DOCKET: EPA-HQ-OAR-2014-0609

**TECHNICAL SUPPORT DOCUMENT FOR SECTIONS 194.23, 194.32, AND 194.33
REVIEW OF CHANGES TO WIPP PERFORMANCE ASSESSMENT
FEATURES, EVENTS, AND PROCESSES IN THE 2014 CRA**

EPA Completeness Questions, DOE Responses, and EPA Evaluations of Responses Related to Features, Events and Processes in WIPP Performance Assessment

Figure 1. Cumulative brine volume passing northward from the waste panel to the SRoR through the panel closure for the 100 vectors of replicate 1, scenario 2 (E1 intrusion at 350 years) (from Zeitler 2015)

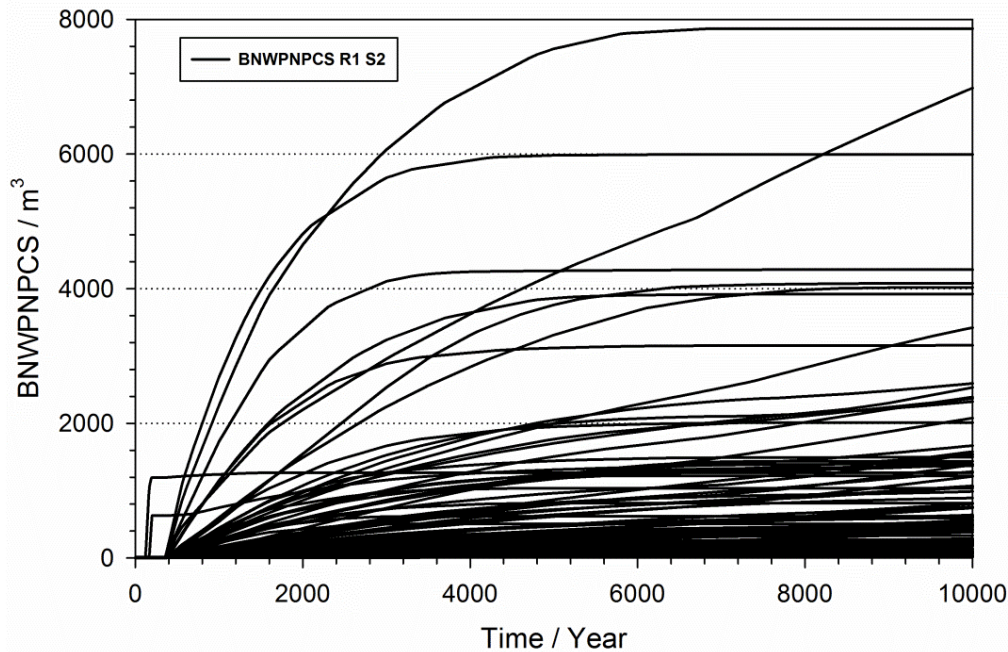
Screening argument considers only boreholes intersecting the waste region. Please supplement the argument with a discussion of boreholes that intersect the non-waste regions and the consequence to PA calculations. Provide references and specific information as to whether boreholes penetrating non-waste regions could result in the transport of radionuclides between the waste and non-waste regions, to overlying units, or to the surface. Provide information, either directly or by reference, as to how deep boreholes penetrating the non-waste and waste regions of the repository are accounted for in the PA.

To update the BRAGFLO results that were used by the CMPRP to make its decision, and verify that it remains appropriate to exclude boreholes in the operations and experimental areas from PA calculations, BRAGFLO results from replicate 1 of the CRA-2014 PA calculations are examined. The maximum brine flow through a panel closure is now about 8,000 m³ following an E1 intrusion, which occurred for brine flow across the panel closure separating the waste panel and southern rest of repository (SRoR) (Figure 1). (BRAGFLO scenarios S2 and S3 consider E1 intrusions.) The expected northward flow across any panel closure is about 1,000 m³ (for brine flow across the panel closure separating the waste panel and SRoR).¹ For undisturbed conditions (S1), the cumulative brine inflow into the operations and experimental areas from all sources ranges from 700 to 35,000 (Figure 2). This flow would, on average, result in about a seventeen-fold dilution of brine flowing in from the waste area following an E1 intrusion (comparing $(35,000 + 700)\text{m}^3/2 = 17,850\text{m}^3$ to $1,000\text{m}^3$).

The CRA-2014 PA results indicate that a total cumulative brine flow into the waste area (including the waste panel, northern rest of repository, and SRoR) is on average about 36,000 m³ following an E1 intrusion at 1,000 years (S3) and about 20,500 m³ following an E2 intrusion at 1,000 years (S5). Given that about 7.5 borehole intrusions are expected to occur during the regulatory period, the total volume of brine potentially available to flow into the waste area could exceed 200,000 m³. Thus, with an incremental supply of only 8,000 m³, the same conclusion as the CMPRP can be reached: [the additional brine volume] “would have no consequential effect on performance assessment results.” Compared to the previous analysis, the maximum brine flow across a panel closure has decreased (12,000 to 8,000 m³) and the total volume of brine potentially available to flow into the waste area has stayed the same (210,000 to 209,500 m³). Thus, the relative amount of “incremental supply” of brine has decreased from $12,000/210,000=0.0571$ to $8,000/209,500=0.038$, indicating approximately a 33 percent decrease in the relative amount of brine available in the non-waste regions of the repository. Therefore, boreholes that intersect the non-waste regions of the repository still do not need to be accounted for in PA calculations.
